GRAZIANI
+
CORAZZA
ARCHITECTS INC.

SITE INSTRUCTION

SI A18

PROJECT : Forestside
PROJECT # : 1331.15
DATE : Mar.14, 2022

**GROUND FLOOR PLAN
BUILDING A (PARTIAL PLAN)**

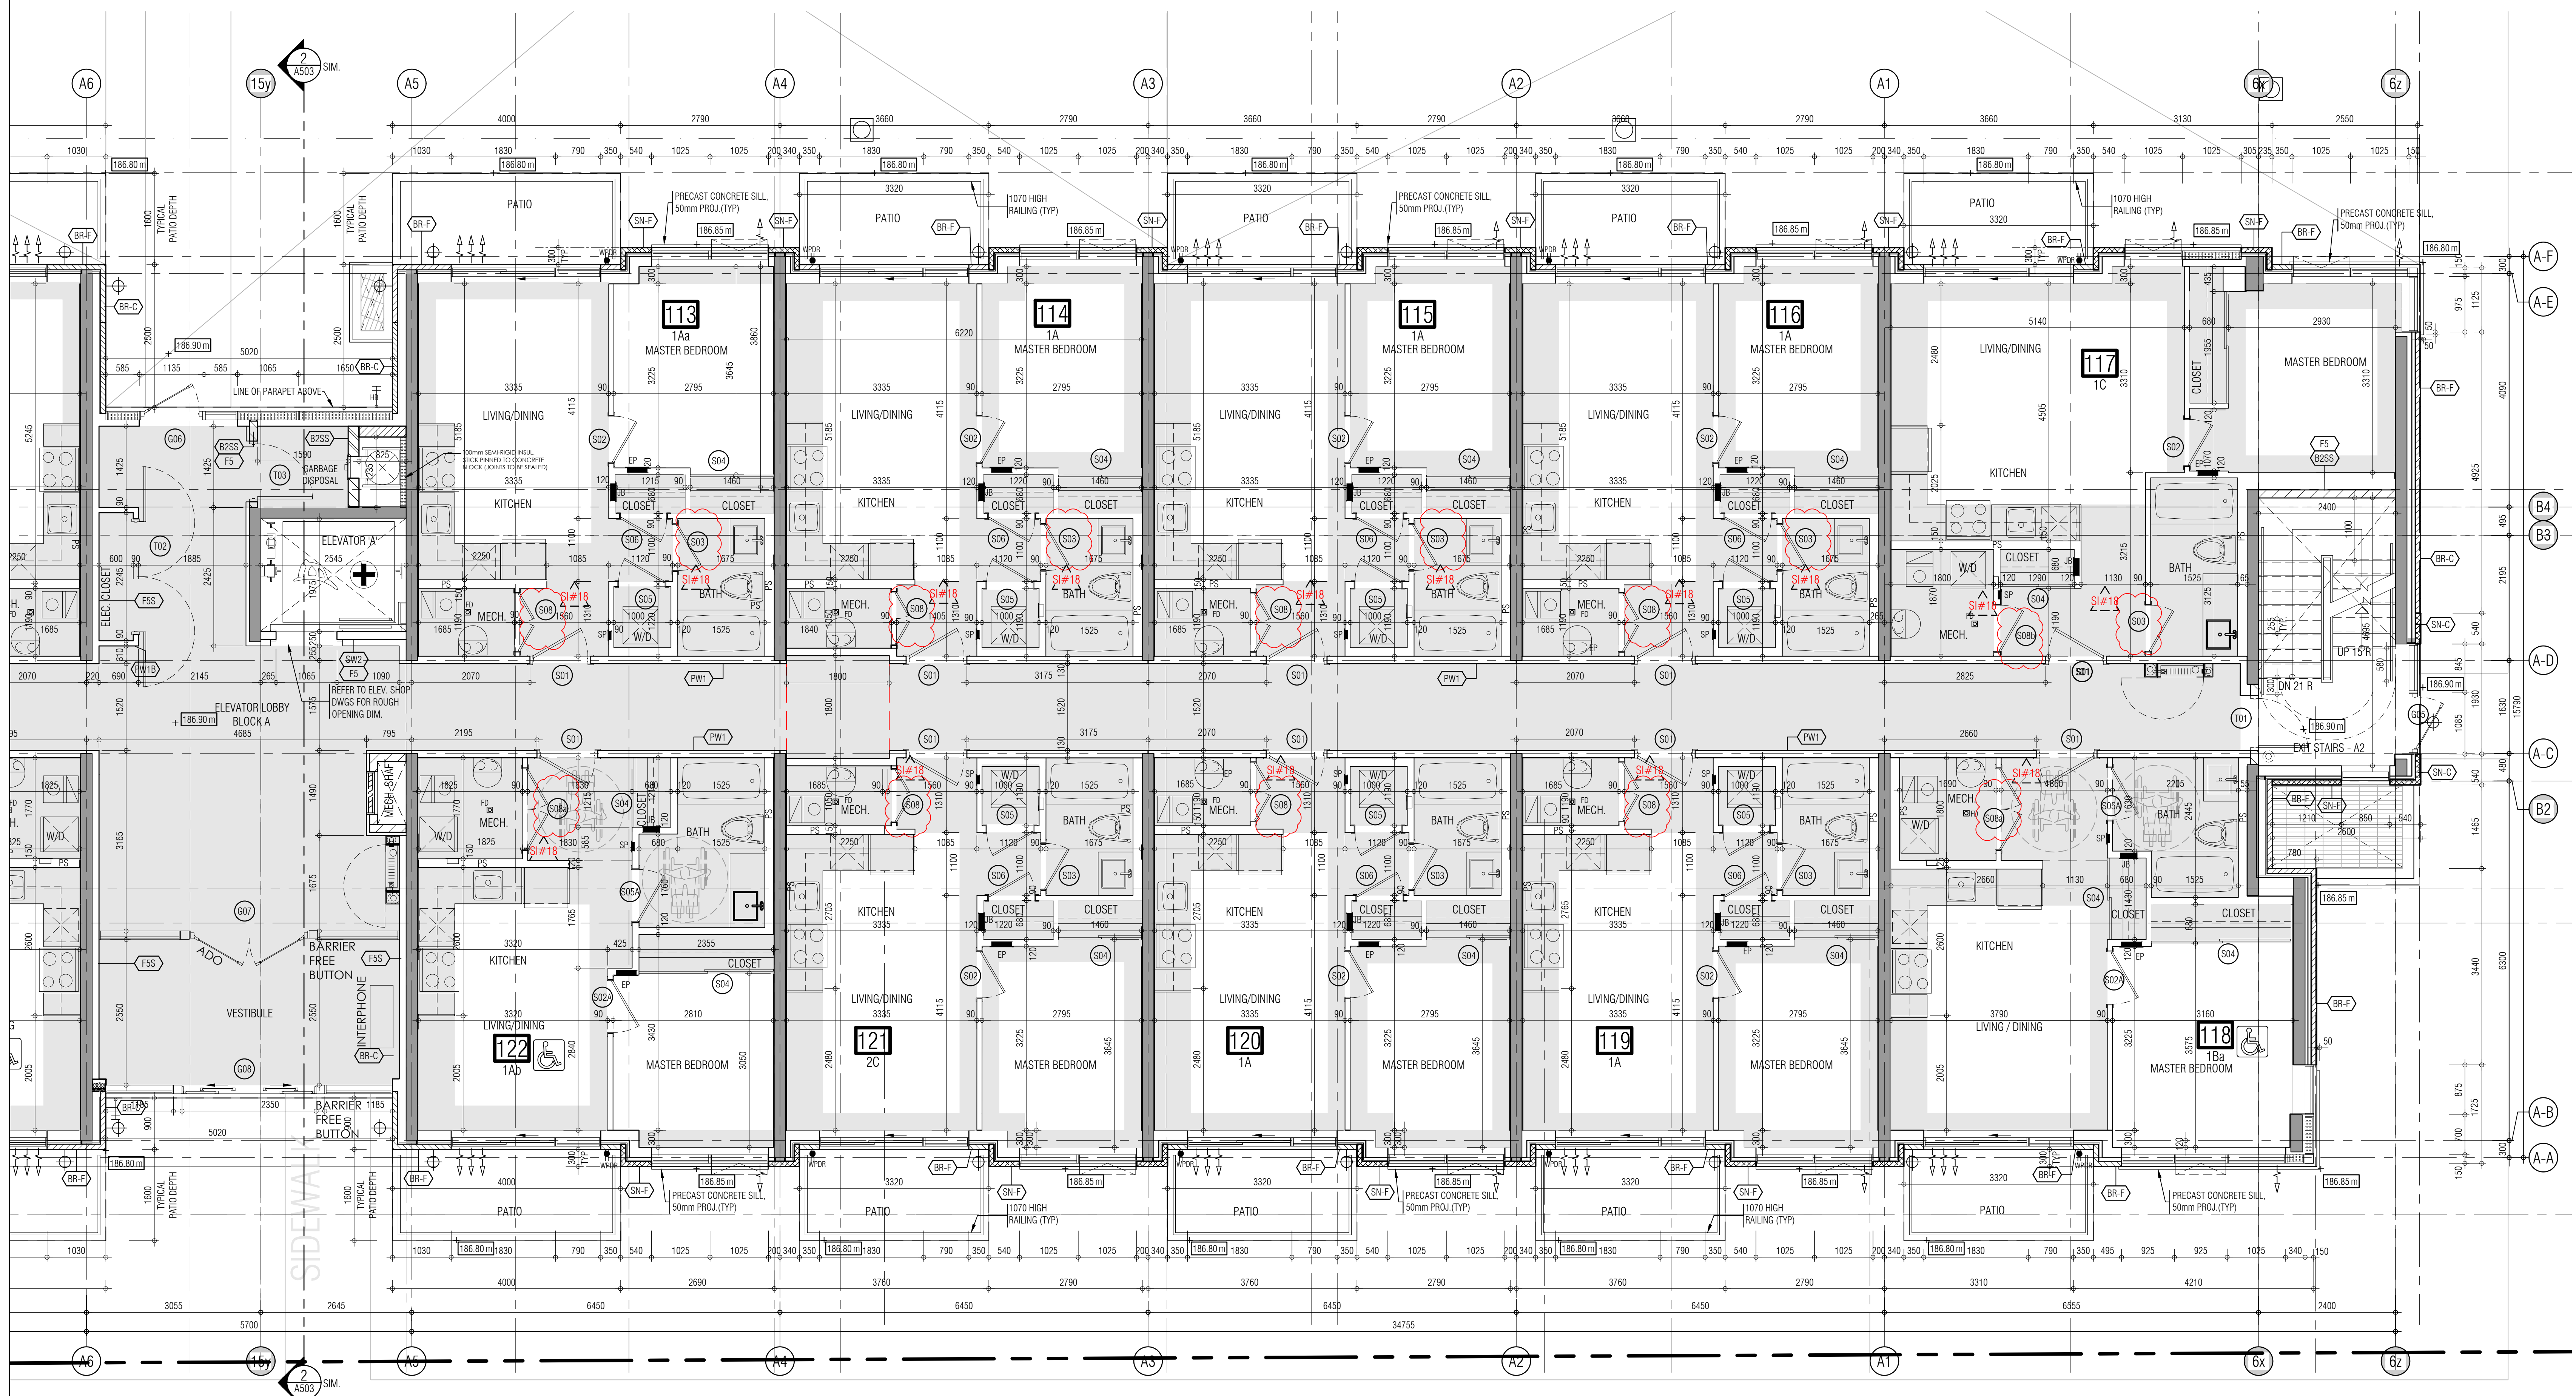
A301a1-A301d2 A302a1-A302d2 A303a1-A303d2	1st to 3rd Floor Plans Bldg. A, B, C, & D	<ul style="list-style-type: none"> • Rename door label from S06 to S03 for Bathroom. • Rename door label for larger mechanical room double doors S08a and S08c, and S08d. • Rename Mechanical room smaller double doors S08.
-------------------------------------------------	----------------------------------------------	---------------------------------------------------------------------------------------------------------------------------------------------------------------------------------------------------------------------------------------------------------------

Reason: Revisions to door designations to floor plans as per door hardware shop drawing coordination.
